Appendix G - Stakeholder Committee Report

Stakeholder Committee Report on **Entergy Arkansas 2024 Integrated Resource Plan**

October 23, 2024

Figure 1: 2027 capital costs of solar, wind, and BESS for Entergy compared to other industry sources³

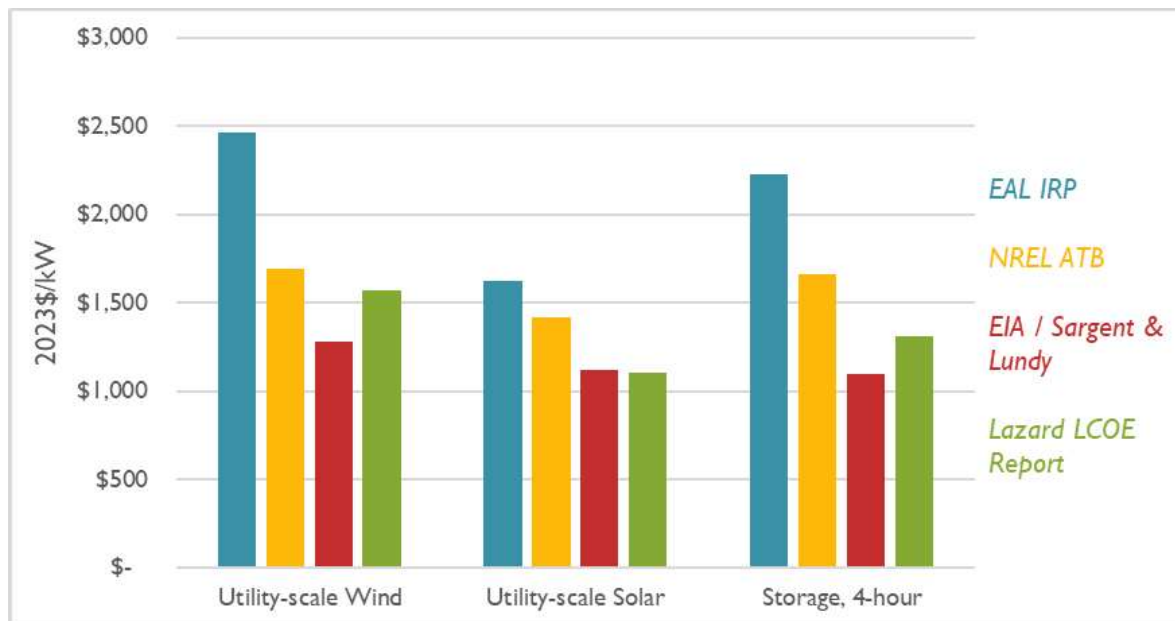
In Figure 1 below, we compare the initial (2027) capital costs of solar photovoltaic (solar PV), wind, and battery energy storage system (“BESS”) resources that Entergy uses to projections from NREL, EIA, and Lazard. On average, Entergy’s cost estimates are 65 percent higher than NREL, EIA, and Lazard for wind, 36 percent higher for solar PV, and 69 percent higher for BESS.

Figure 2: Solar cost trajectories for Entergy compared to other utilities and industry sources⁵

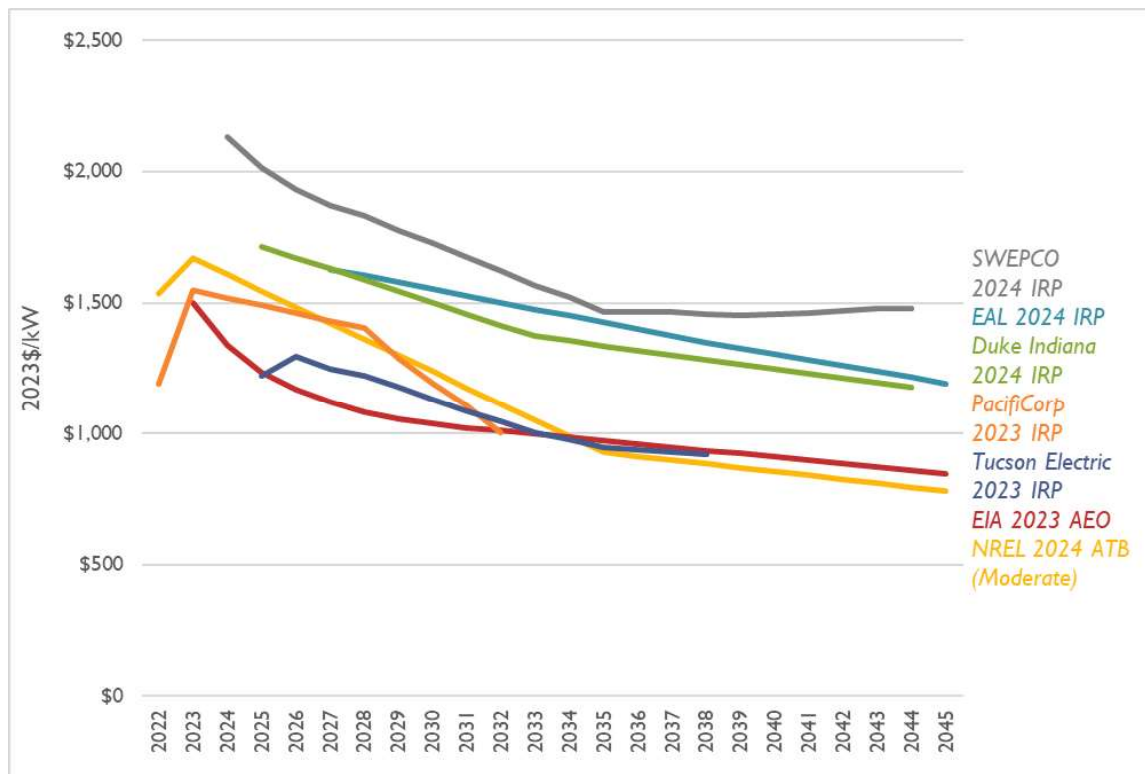
In Figure 2, Figure 3, and Figure 4 below, we compare Entergy’s long-term cost estimates (now through 2045) for these same technologies to other industry forecasts. Entergy does assume that costs will decline over time due to technology maturation, but it uses the conservative learning curve assumptions from NREL’s Annual Technology Baseline (“ATB”).⁴ Unless there is a clear justification for a slower rate of learning in Entergy’s service area, it would be more reasonable for Entergy to use the ATB’s moderate assumptions for planning purposes. Both because of the conservative learning curve and because its cost assumptions start above other sources we reviewed, Entergy’s costs remain substantially higher than industry standard projections and other utility projections for the entire study period. Entergy’s forecasts for solar PV, wind, and BESS are the highest, or among the highest, of all utilities we reviewed.

Figure 1, Map of “Energy Communities” in Arkansas as of Oct. 2024¹⁸

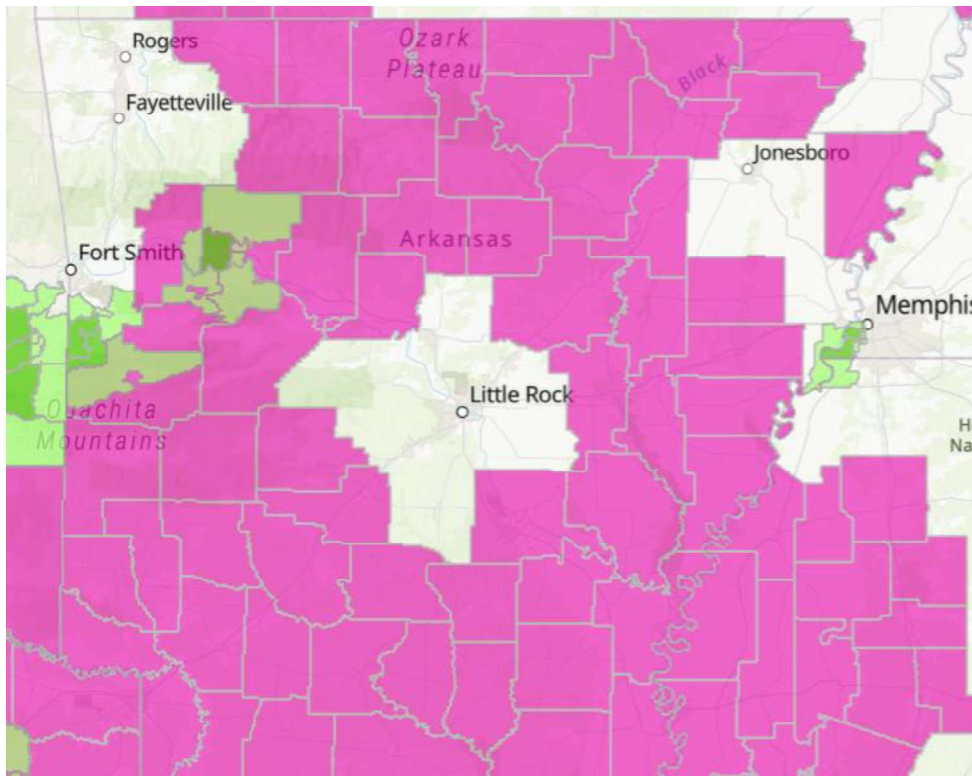
First, nearly all of Entergy Arkansas’s service area is currently considered by the IRS to be an “energy community” under the IRS. In other words, a randomly sited solar project in Arkansas would have a high probability of being located in an “energy community.” But, in addition, there

is no reason to expect developers to randomly site solar project when they know that a project located in an “energy community” is 10% cheaper for a utility purchaser.

Simply put, Entergy is wrong to exclude the 10% “energy community” adder from its modeling in this IRP, when it is likely that such increase in the tax credits will be available for Arkansas-located solar projects, and it is even more likely that that such credit increase would be available for a storage project located at the site of its own retired coal units, a siting decision that is within Entergy’s control. Entergy should be required to update its modeling to include consideration of these tax credits.

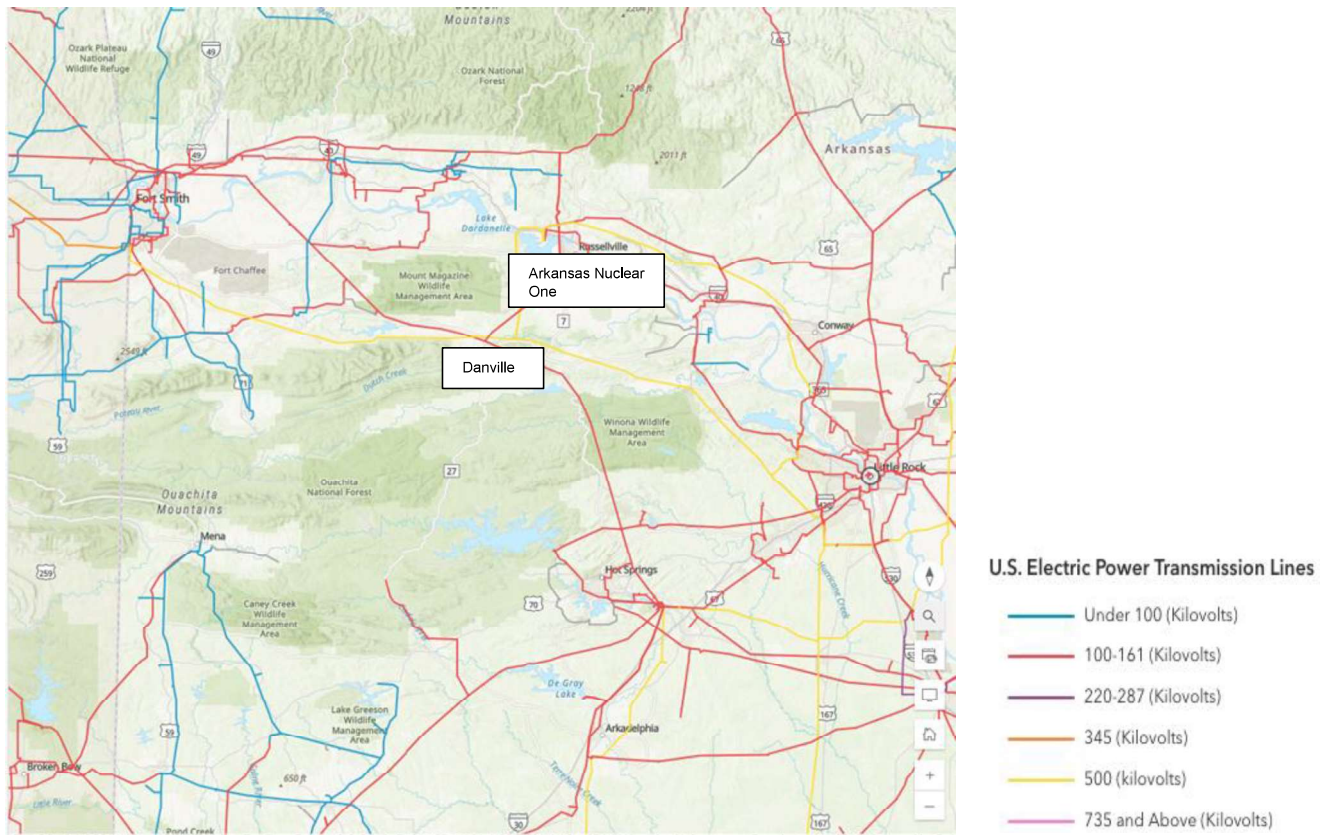
reconductoring lines far more economically than building a 600-mile HVDC line. However, EAL uses the high cost of the HVDC option as a strawman to block importing energy from SPP rather than as a serious resource proposal.

A public domain transmission map⁶¹ shows the presence of strong interconnection capacity between western Arkansas and SPP with 500kV lines (yellow in the map) originating at the 1,800 MW Arkansas Nuclear One power station, ostensibly flowing power west through Danville towards Fort Smith, suggesting there could be available capacity from Western Arkansas wind regions or from SPP into Danville where power flows would be in the opposite direction from the nuclear station. Elsewhere, interties at the EHV New Madrid substation connect to multiple regions, Southern Arkansas has connections through Louisiana to SPP among others.
